Road Safety Audit Response for Stage 1 Road Safety Audit (GG 119 Appendix F)

Report Title:	Stage 1 Road Safety Audit Designer's Response
Date:	06 May 2025
Document Reference and Revision:	23138 RSA1 Designer's Response (Rev C)
Prepared By:	Milestone Transport Planning Ltd
On Behalf of:	Croudace Homes Limited

Project:	Proposed Residential Development, Land at Bird in Eye Farm, South of Bird in Eye Hill, Framfield, Uckfield, TN22 5HA
Report Title:	Stage 1 Road Safety Audit Response
Prepared by:	
Name:	Paul Koven
Position:	Associate Director
Signed:	
Organisation:	Milestone Transport Planning Ltd
Date:	06 May 2025
Approved by:	
Name:	Matt Stevens
Position:	Executive Director
Signed:	
Organisation:	Milestone Transport Planning Ltd
Date:	06 May 2025

Table F.4 Road Safety Audit Decision Log

Drawing Number: 23138/001

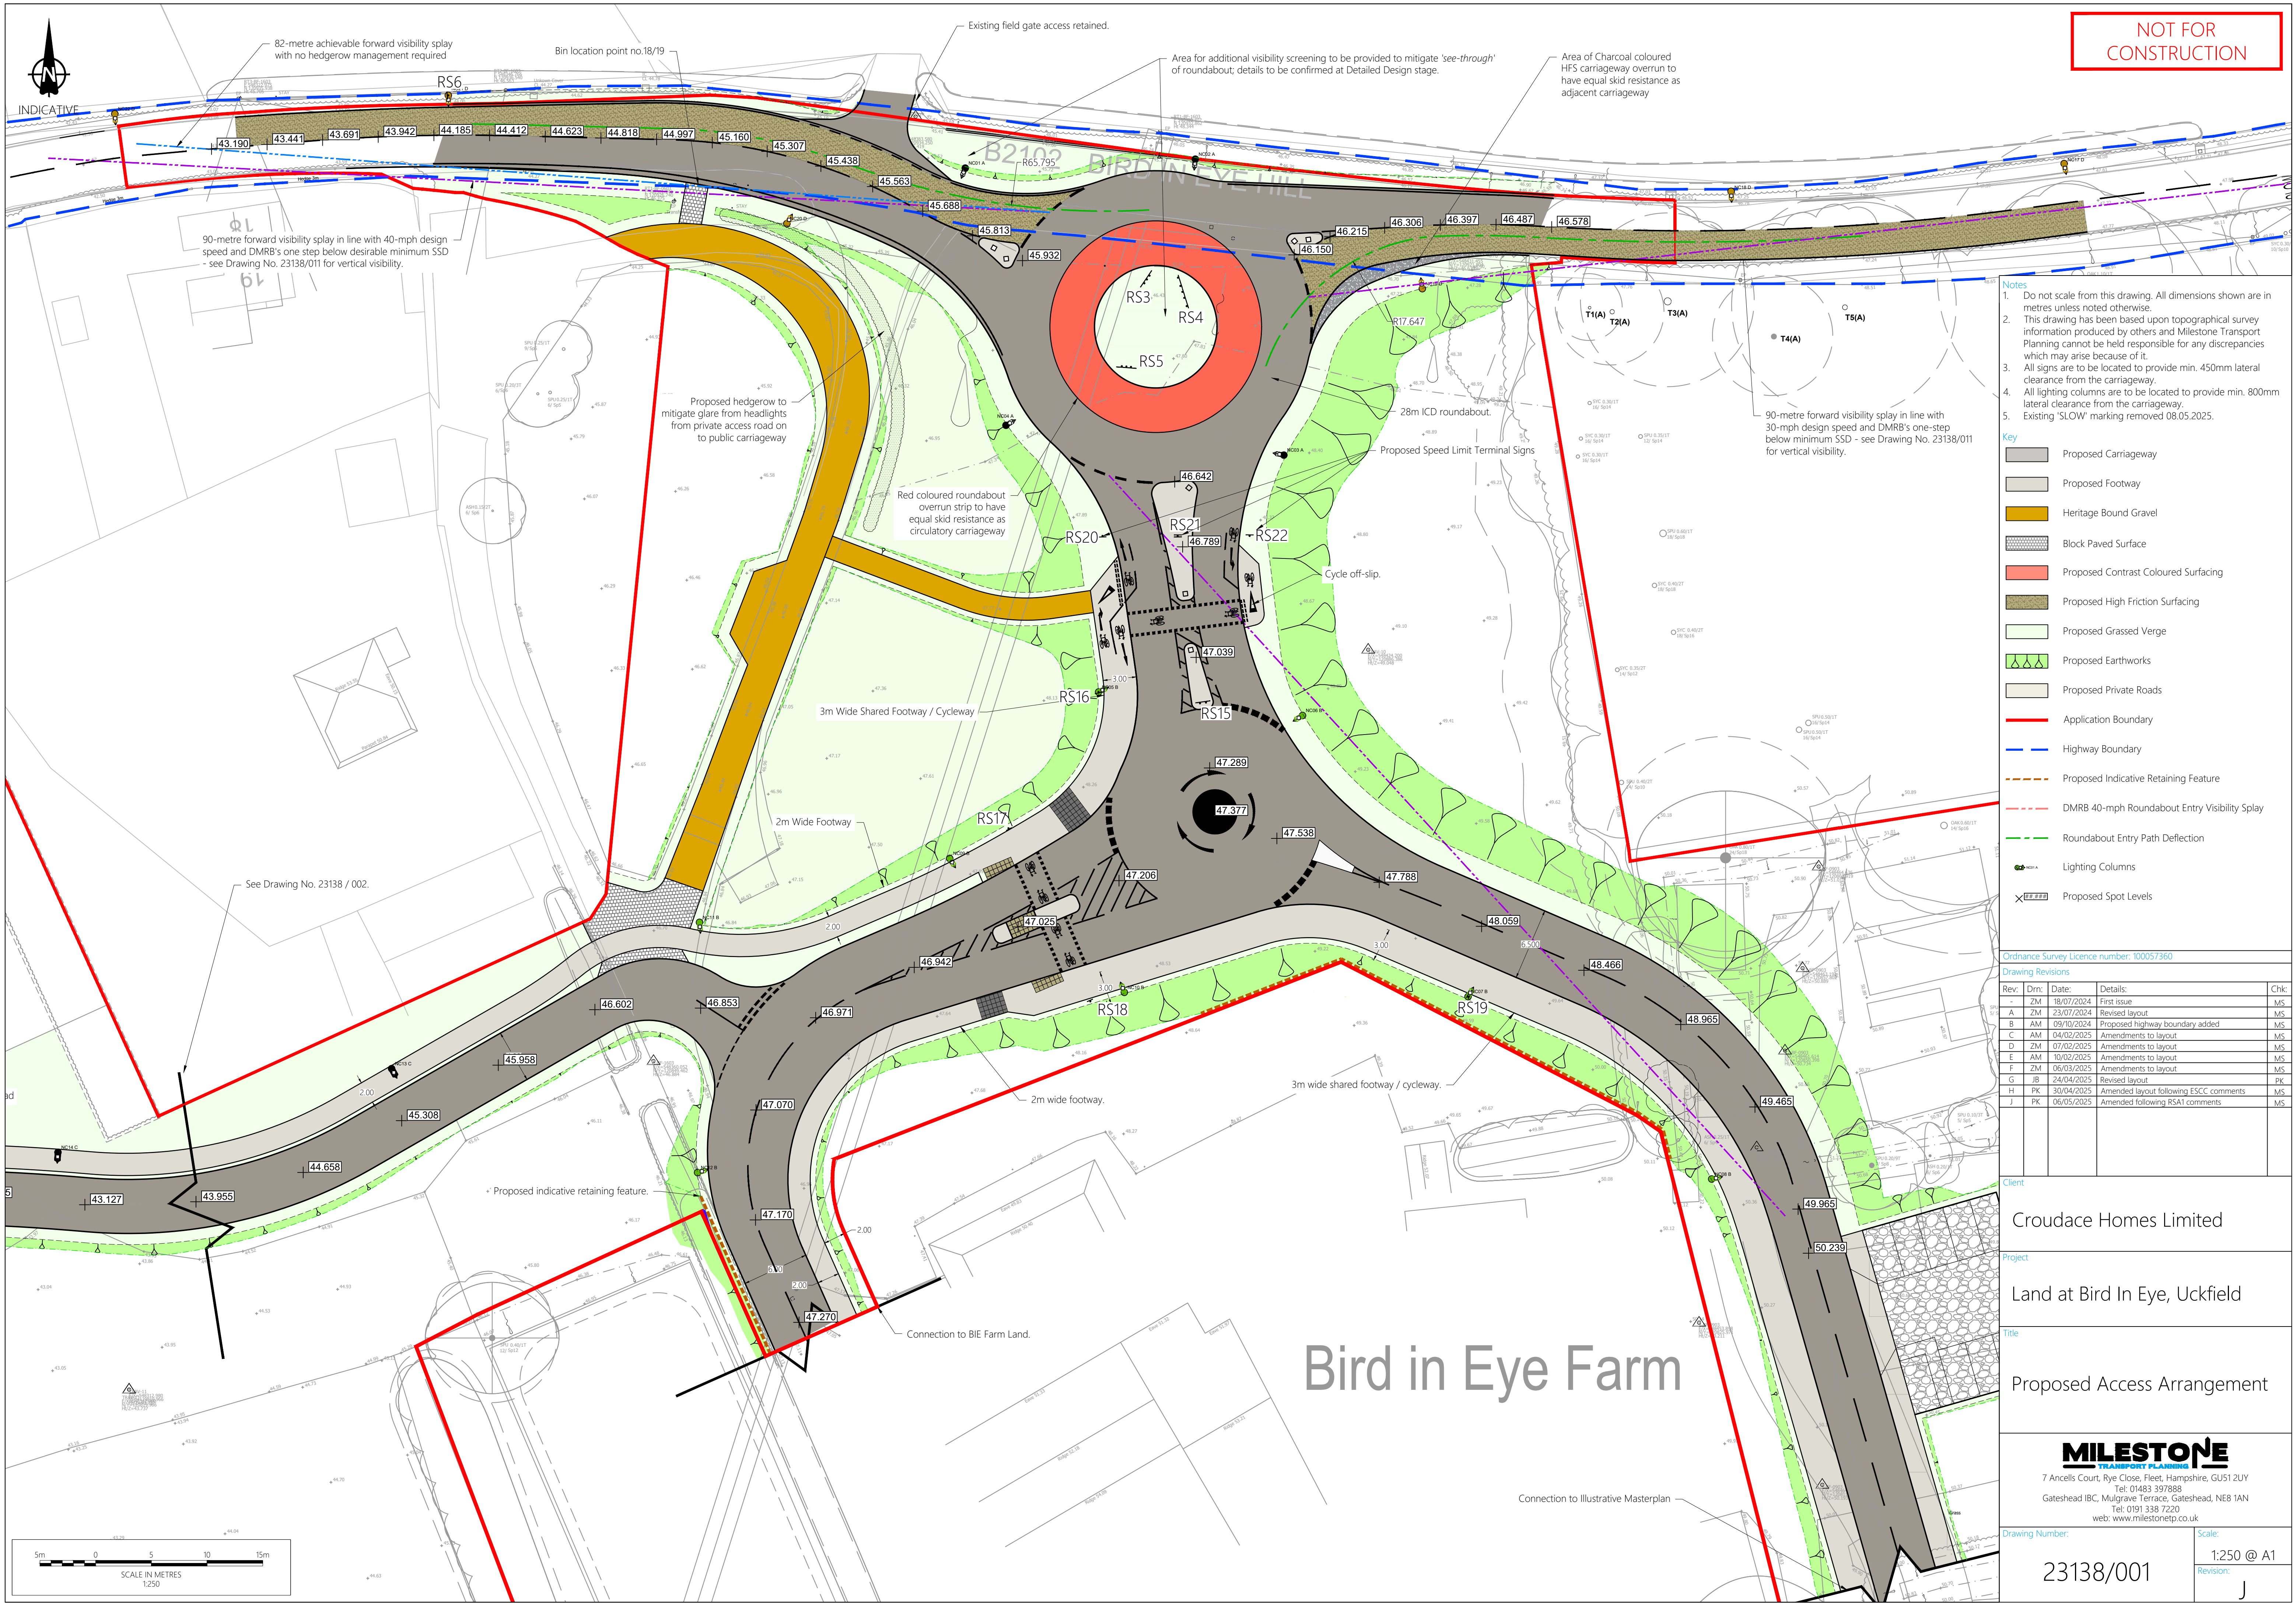
2.1 General Matters	
Location - South arm of new roundabout, including mini roundabout	
RSA Problem	Collisions and increased casualty severity due to inappropriate vehicle speeds. Drivers will enter the development from the new 40mph speed limit, but it is unclear what speed limit will apply within the development. Inappropriate vehicle speeds may lead to collisions between vehicles at the mini roundabout or between vehicles and other road users, particularly at crossing points, and potentially with higher degrees of casualty severity.
RSA Recommendation	Introduce a 30mph speed limit on the south (development) arm of the new roundabout.
Design Organisation Response	Agreed - 30mph / 40mph speed limit terminal signs are now proposed on the southern arm of the new roundabout.
Overseeing Organisation Response	This addition is acceptable.
Agreed RSA Action	Proposed speed limit terminal signs to be included as part of design.

2.2 Local Alignment	
Location - Westbound exit from new roundabout.	
RSA Problem	Collisions due to headlight dazzle and confusion. Westbound drivers exiting the roundabout at night may be faced by a vehicle departing from Nos. 18/19 Bird In Eye Hill and could be dazzled or confused by oncoming offside headlights, leading to loss of control type collisions.
RSA Recommendation	Extend the proposed hedge or provide an alternative form of screening along the full length of the outside of the bend of the new access road to Nos. 18/19 Bird In Eye Hill, to remove the potential for westbound drivers to be dazzled or confused by oncoming offside headlights.
Design Organisation Response	Agreed - Proposed hedgerow has been extended to reduce the likelihood / risk of headlights dazzling oncoming vehicles.
Overseeing Organisation Response	The inclusion of the screen is as recommended by the LHA, and its extension is supported but which should not extend into the proposed extent of the highway. This is to prevent obstruction of the forward visibility sightlines when travelling eastbound.

2.3 Junctions	
Location - Framfield Road westbound approach to roundabout.	
RSA Problem	Collisions due to 'see-through'/junction overshoot. Westbound drivers on Framfield Road may have a clear view ahead despite the visibility screening on the offside (north side of eastbound approach). This may lead to junction overshoots and collisions with other vehicles at the roundabout, exacerbated during inclement weather conditions.
RSA Recommendation	Extend (northwards) the chevron sign on the roundabout central island facing the westbound approach.
Design Organisation Response	Agreed - Proposed sign RS4 has been amended and relocated as far as practically possible (maintaining a safe lateral clearance from the proposed kerbline) to reduce potential 'see-through' visibility.
Overseeing Organisation Response	This change is accepted.
Agreed RSA Action	Rearrangement of sign RS4 layout and position to be included within design.

Agreed RSA Action	Hedgerow to be extended as part of design but kept out of public highway land. Inclusion of screen as per LHA requirements to be included within designs.
